Information Bulletin

Bulletin No: JC-18-21

Product Type: ZTS Lawnaire

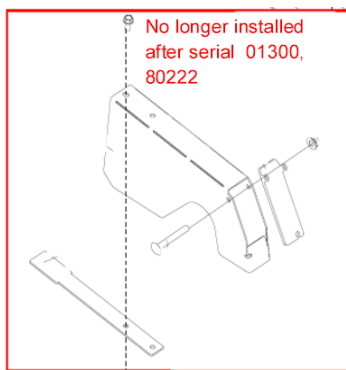
Customer Issue: Chain guard gets bent and hits other components in the machine.

Cause: Debris stuck on the tines hits the guard.

Action: We have removed the guard from new production units starting with serial number 01300 for the 554930A and 080222 for the 554930ACA. Initially, the intent of the chain guard was to protect the chain sprocket from dirt. After careful consideration and feedback from our customers, the guard will be subject to damage from debris like sticks, cans and other solid objects collecting on the tines.
